GFA AIRWORTHINESS DIRECTIVE

SUBJECT: Cracking of flap drive. Issue 3 of this AD corrects an omission in Issue 2 by adding Ventus bT to the affected models. Otherwise the content of the AD and the attachments are unchanged.

**Airworthiness
Directive
2001-258**

SUBJECT: Flap drive inside the fuselage

Schnitt A-B

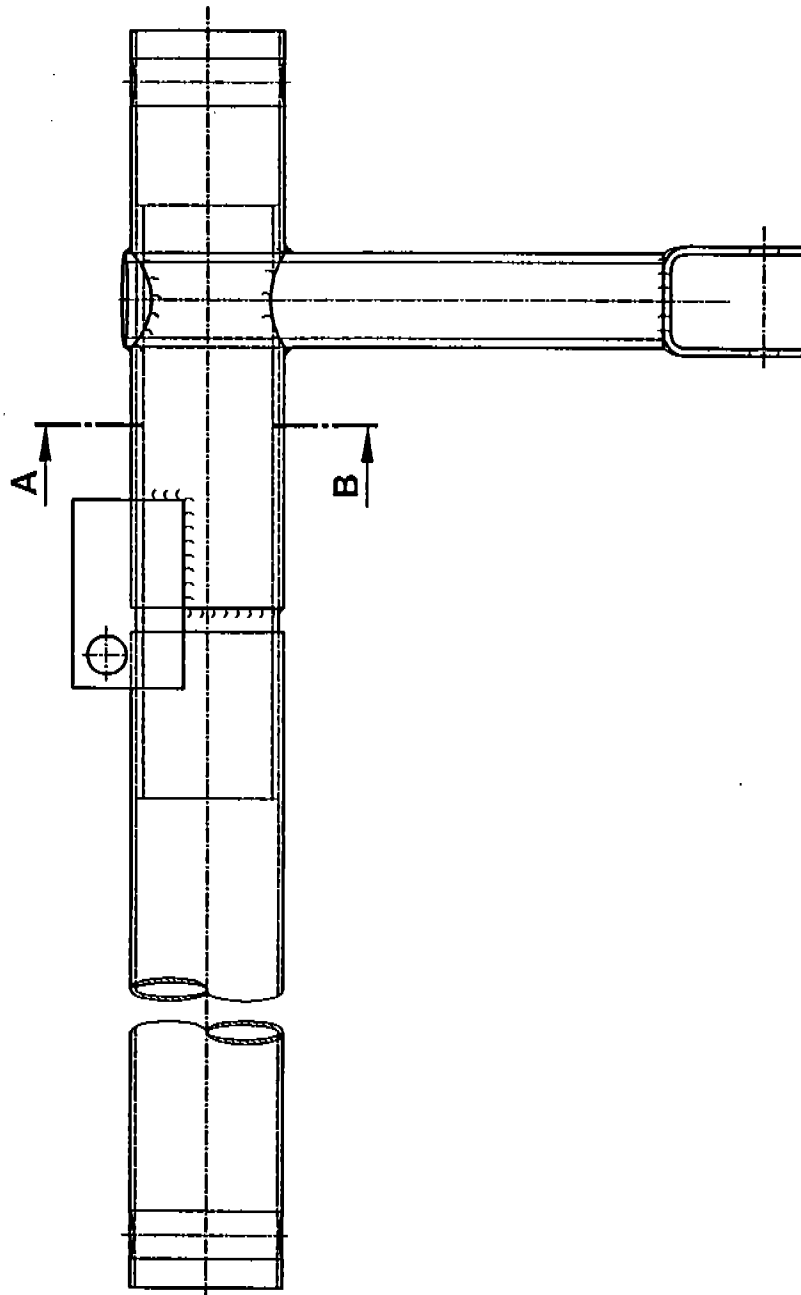
- ACTIONS:
1. Sailplanes Ventus b and Ventus b/16.6 with a flap drive design according page 01 of the appendix to this technical Note are not affected of action 2.
 2. The reinforcement of the flap torsional drive must be done in accordance with the working instructions given in the appendix to this Technical Note and must comply with the following drawings:

b) Pull tube halve apart and remove port part.
3. Weld reinforcements to port torque tube as shown in drawing No. HS8-10.084 Modification “a” respective HS8-10.148/1.
4. Reverse steps to re-assemble flap drive.
5. With the sailplane rigged, adjust the starboard flap such that its setting corresponds with the marking previously applied (see 1. a)

a) The torque tube is disconnected by removing the rear lock nut (14 a) and loosening the clamping nut (14 b) – then the hexagonal bolt (10) must be turned out (with nut 14 b held fixed) until the two parts of the torque tube are apart.

Adjusting the split torque tube is by means of the hexagonal bolt (10).
To turn this bolt (10), the clamping nut (14 b) must be loosened.

The lock nut (14 a) is tightened against the threaded bushing (4) only after the adjustment of the flaps is completed.
